Highways Update

0934 – Marled Hay, Stockbridge Village

Public consultation site plan

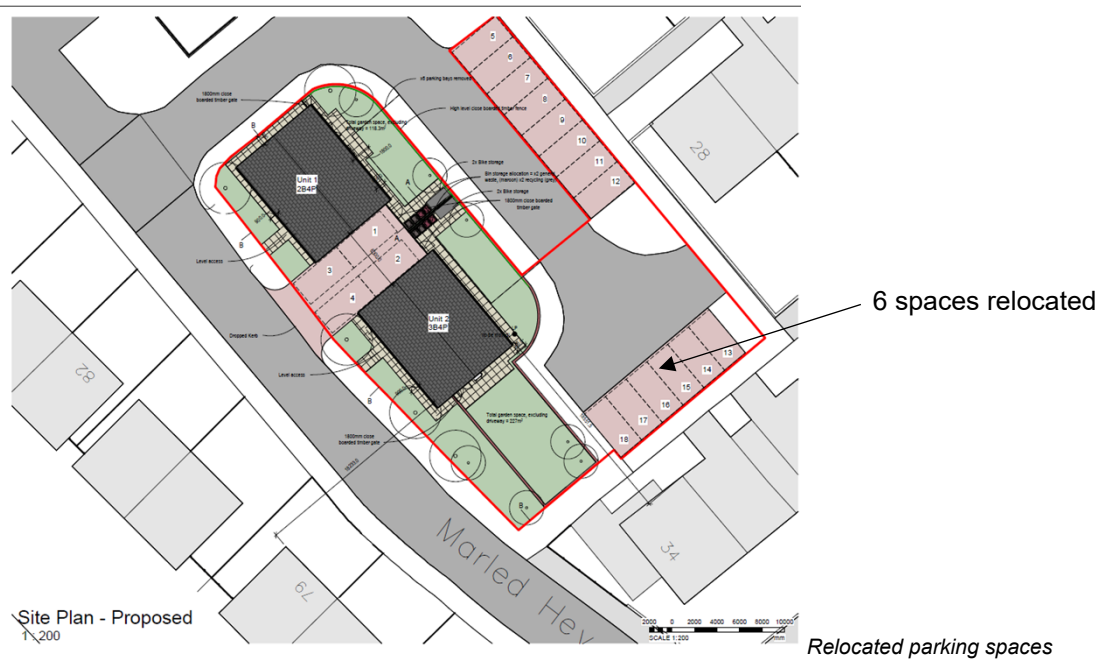
The residents raised concerns over the loss of 7 number parking spaces.

Following the public consultation, the redline boundary was extended to include the turning head to accommodate the relocation of 6 of the parking spaces to the west of the turning head resulting in the loss of 1 parking space overall.

In addition, residents are currently parking within the turning head causing a highways safety issue as refuse vehicles would not be able to utilise the turning head and would have to reverse out of the site.

Our proposal although reducing the total number of parking spaces by 1 space; would have the advantage of improving highway safety.
